YAMAHA

PARTS CATALOGUE

GOLF CAR

TECHNICAL BULLETIN

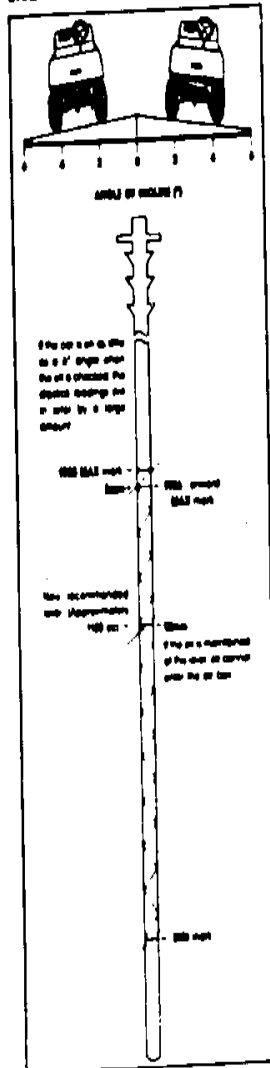
Customers should be cautioned that the oil level should be checked only when the car is on level ground. As seen in the illustration, with the car on as little as a 6° incline (normal road drainage pitch is about 4°), the dipstick can be easily misread.

By reducing the oil level in the engine to approximately 100 cc, this problem will no longer occur.

When adding or changing oil, the engine should be filled with 100 cc of oil. This amount lowers the oil level to a point on the dipstick between the MAX and MIN marks, about one-third the distance below the MAX mark (2mm). Do not fill above this point. This slightly reduced oil level will not affect lubrication. The oil level warning system still gives ample notice when oil must be added.

If desired, the dipstick can be remarked at the level indicated after an oil change. As usual, make sure both the dipstick and the oil-filler cap are firmly in place after any oil servicing to ensure proper circulation of oil in the cylinder head and that the governor is adjusted to factory specifications.

CORRECT FOR G2-A
NGK B5E5 or CHAMPION NS, NSC

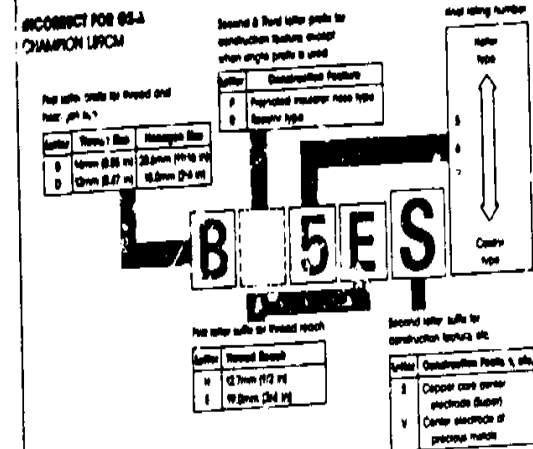
INTRODUCTION
The CHAMPION spark plug used on pages 7-29 and 8-7 in the G2-A Service Manual is incorrect. The correct spark plug has a 3/4" thread reach and not 1/2" as listed in the manual. Performance is adversely affected by using the incorrect spark plug.

HOW TO READ SPARK PLUG I.D. NUMBERS
If replacement of the spark plug is necessary, use the correct type/number/range as listed. Spark plug installation torque is 14 ft lb (2.0 Nm).

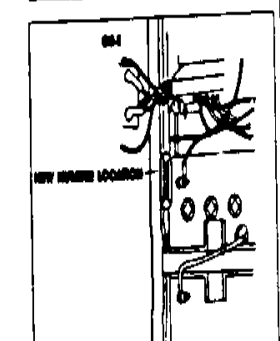
INTRODUCTION
The placement of the stamped-in primary ID number on the vehicle frame has been changed. See the illustrations for the new locations.
NOTE: The G2-A engine number location remains the same.

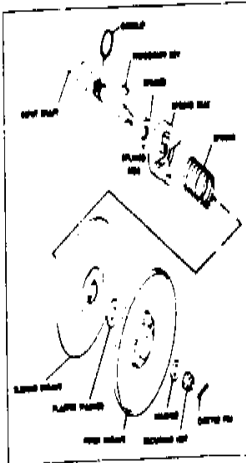
REMEDY Replace the spring seat circlip with the new spacer.

1 Follow service manual instructions to remove the rear body and the secondary clutch fixed sheave.

2 Remove the plastic washer, woodruff key, sliding sheave, and spring seat. Remove the circlip. Tag the circlip with a Warranty Parts tag and hold for 90 days from the date the Warranty Request is submitted. The circlip is not used with the new spacer.
